COUNCIL ASSESSMENT REPORT

Panel Reference	2017SCL041
DA Number	DA/82/2017
LGA	Randwick City Council
Proposed Development	Demolish existing buildings in order to enlarge the school. Demolition is to include the existing cottages at nos.24 and 26 Bruce Street, as well as the single storey school building at nos.28 and 30 Bruce Street. The new two storey building is to comprise classrooms, amenities and an undercover multipurpose room associated with St. Spyridon's school.
Street Address	24-30 Bruce Street Kingsford
Applicant/Owner	The Greek Orthodox Parish of South East Sydney
Date of DA lodgement	22 February 2017
Number of Submissions	No submissions
Recommendation	Approval
Regional Development Criteria (Schedule 4A of the EP&A Act)	6 Private infrastructure and community facilities over \$5 million Development that has a capital investment value of more than \$5 million for any of the following purposes: (a) air transport facilities, electricity generating works, port facilities, rail infrastructure facilities, road infrastructure facilities, sewerage systems, telecommunications facilities, waste or resource management facilities, water supply systems, or wharf or boating facilities

Figure 2: Eastern elevation of proposed development along Bruce Street. Adjoining to the right is No. 22 Bruce Street a two storey dwelling.

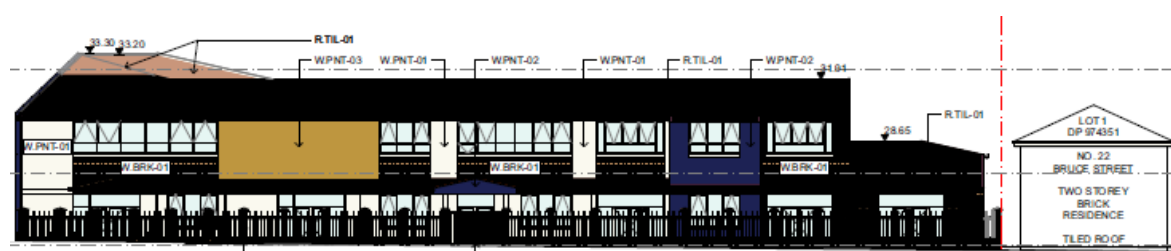
The proposed building has a maximum height above natural ground level of 10.22m (RL33.30 – RL23.08) at the southern side of the building adjoining No. 62-60 Gardeners Road. The building along the northern side of the site - adjoining a two storey dwelling at No. 22 Gardeners Road - has a height of 4.95m and setback 900mm from the side boundary. The first floor level at the northern side of the site has a height of 8.9m and setback 8.1m from the northern side boundary. Figure 2 below shows the development from Bruce Street.

Figure 3: Southern elevation of the proposed development showing in red outline the area of the building exceeding the maximum 9.5m height of buildings standard in the RLEP 2012.

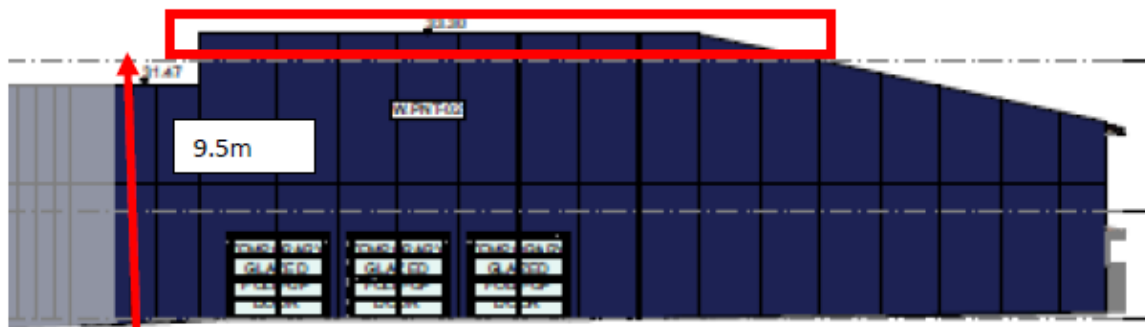
- The proposed development will result in a breach of the height of buildings development standard by approximately 720mm along a portion of the southern elevation as shown in figure 3 below:

- The exceedance in height occurs at a setback from the Bruce Street frontage providing a 6.5m wall height along the Bruce Street frontage and a height between 7.51m and 8.71m wall height along the Mary Harmer Lane frontage
